UNITED STATES
NUCLEAR REGULATORY COMMISSION
WASHINGTON, D.C. 20555-0001

SUBJECT: THREE MILE ISLAND NUCLEAR STATION, UNIT 1 – ISSUANCE OF
AMENDMENT NO. 297 RE: DEFUELED TECHNICAL SPECIFICATIONS AND
REVISED LICENSE CONDITIONS (EPID L-2018-LLA-0204)

Amendment No. 297
Renewed License No. DPR-50

Figure 3.1.3-1
Minimum Burnup Requirements for Fuel in Region II of the Pool A Storage Racks

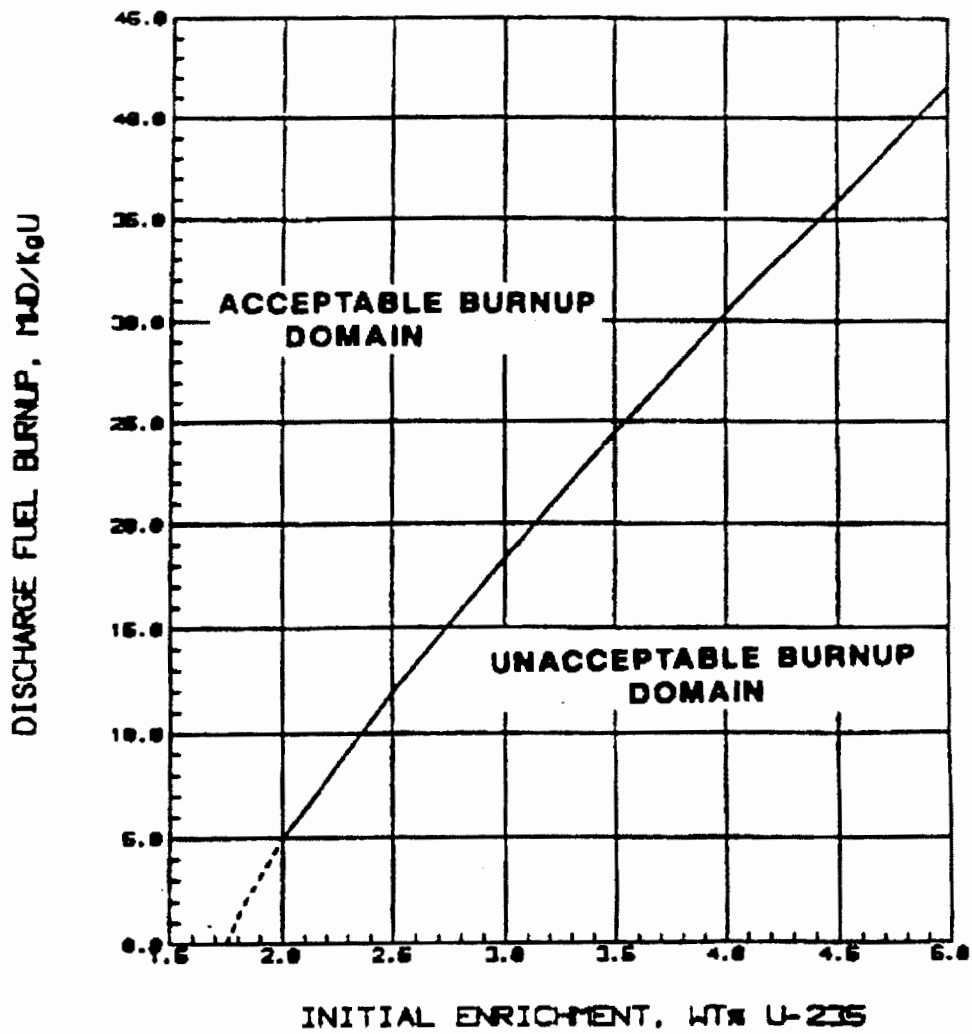
TS 5.4.2.g is proposed to be relocated. The TS and Figure 5-4, "Minimum Burnup Requirements for Fuel in Region II of the Pool 'A' Storage Racks," will be relocated to proposed TS LCO 3/4.1.3, "Spent Fuel Assembly Storage." This is discussed in Section 3.6.3 of this safety evaluation.

- 3.1.3.1 The combination of initial enrichment and burnup of each spent fuel assembly stored in Storage Pool A and Storage Pool B, shall be within the acceptable region of Figure 3.1.3-1 or 3.1.3-2.
- 3.1.3.2 When requirement of 3.1.3.1 is not met, immediately initiate action to move the noncomplying fuel assembly to an acceptable configuration.

Figure 3.1.3-2
Minimum Burnup Requirements for Fuel in the Pool B Storage Racks

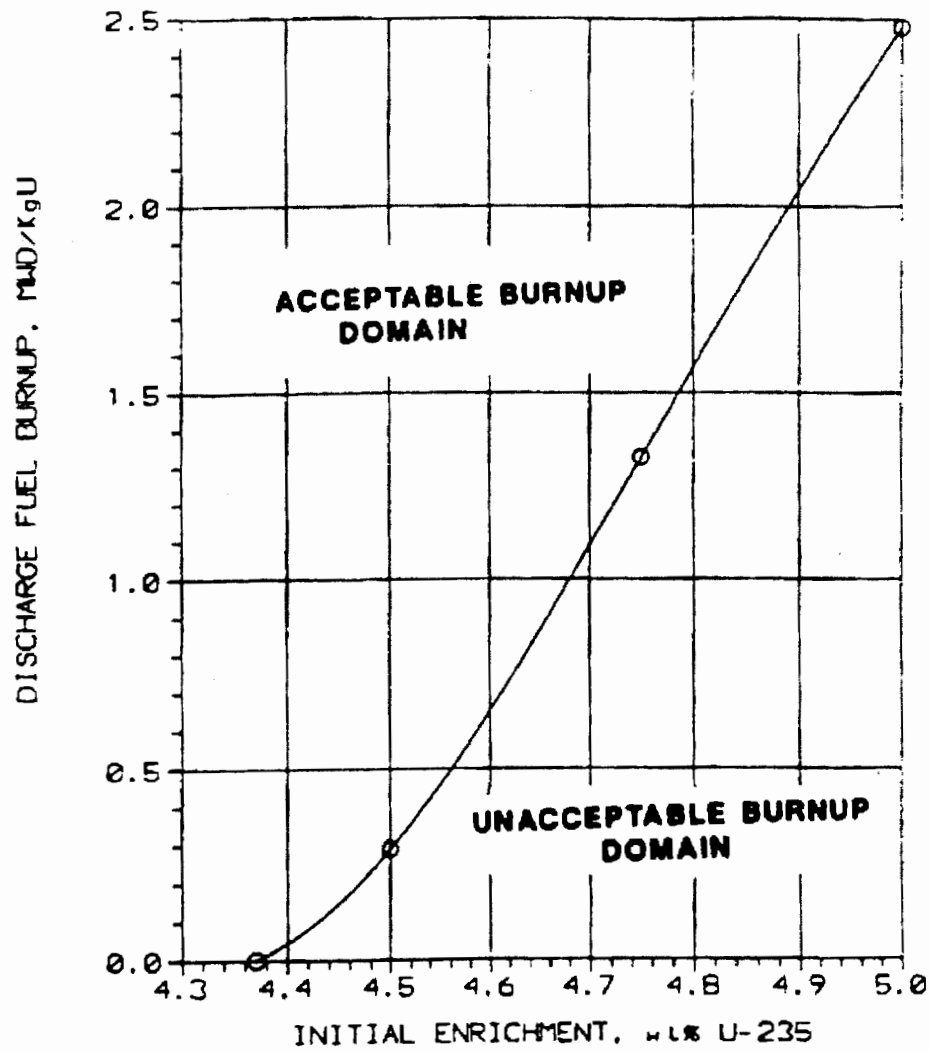
TS 5.4.2.h is proposed to be relocated. The TS and Figure 5-5, "Minimum Burnup Requirements for Fuel in the Pool 'B' Storage Racks," will be relocated to proposed TS LCO 3/4.1.3, "Spent Fuel Assembly Storage." This is discussed in Section 3.6.3 of this safety evaluation.
